REQUEST FOR Class II Permissive Change

Request of Class II Permissive Change

Company name Sun Cupid Technology (HK) Ltd.
FCC ID: 2ADINS6003L
FCC Part 15 Certification

CPU:

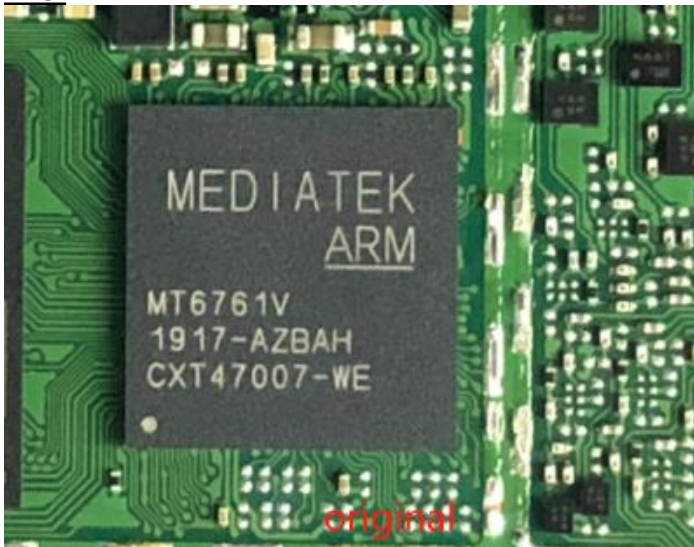
Change 1: **Change the Chipset from MT6761V/WE to MT8766V/WBA(Pin to Pin replacement CPU).**
So need to retest EMC,2.4GWIFI BLE BT retest Radiated Emissions in Non-restricted
Frequency Bands,GSM WCDMA LTE retest spot test Field Strength of Spurious
Radiation,5GWIFI retest Unwanted Emissions

The RF parameters have not changed, and the antenna and antenna position have not
changed
